SUBJECT: EPA Review of Los Angeles Corps District Memorandum for the Record (March 24, 2021), Approved Jurisdictional Determination, East Review Area, Rosemont Copper Mine Project, Pima Co., Arizona

DATE: May 7, 2021

Prepared by Robert A. Leidy, PhD, Wetlands Office, EPA Region 9, San Francisco, CA

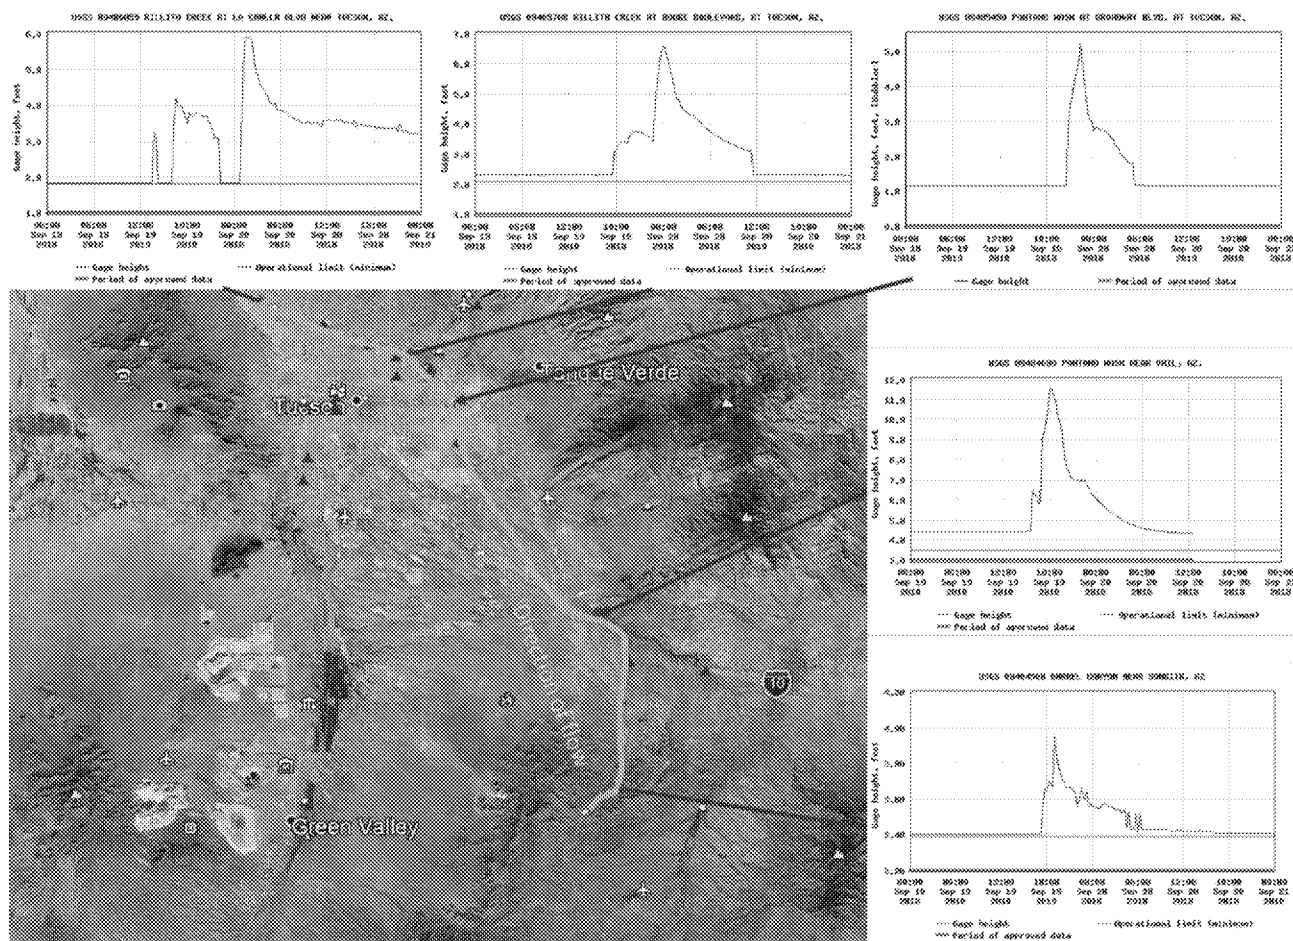
EPA reviewed peak stream discharge data from seven USGS and Pima County stream gages (i.e., September 19-20, 2018, September 3-4, 2015, September 9-10, 2011, July 29-30, 2010). During these periods, surface flows from the East Review Area connected directly to the Santa Cruz River TNWEPA and indirectly through four (a)(2) tributaries (Attachment 1).² The December 19-20, 2018 peak discharge data provides an example of the continuity of flow through various gages from the East Review Area to the Santa Cruz River (Figure 1). The USGS Barrel Canyon gage (9484580) at the downstream boundary of the East Review Area lies from 2.3 to 5.1 miles downstream from the five intermittent ARs within the East Review Area (Table 2). Peak flows at the Barrel Canyon gage for the four periods are as follows: 2010 (mean peak = 50 cfs); 2011 (1,780 cfs); 2015 (528 cfs); 2018 (mean peak = 1.18 cfs). The nearest (a)(2) tributary reach to the East Review Area is the near Barrel Spring that lies 3.1 to 5.7 miles downstream from the five East Review Area ARs (Table 2).

The Barrel Canyon gage reflects streamflow contributions from all upstream tributaries within the East Review Area. Barrel Canyon and its tributaries are losing streams (i.e., streams that lose water through infiltration as they flow downstream). Thus, the total flow measured at Barrel Canyon gage will generally be less than the total combined flow amounts of tributaries at any point upstream of the gage. Flows recorded at the Barrel Canyon are a proxy (i.e., data used to represent the value/presence of upstream flows in a calculation) for all contributing tributaries upstream of the gage. For example, peak flows recorded at the Barrel Canyon gage for 2011 and 2015 were 528 cfs and 1,780 cfs, respectively (Attachment 1). These peak flows represent the combined total contributions for all streams upstream of the gage. These measured flows provide compelling evidence of surface connections between all streams with the East Review Area and the Barrel Canyon gage and downstream surface waters recorded at other gages.
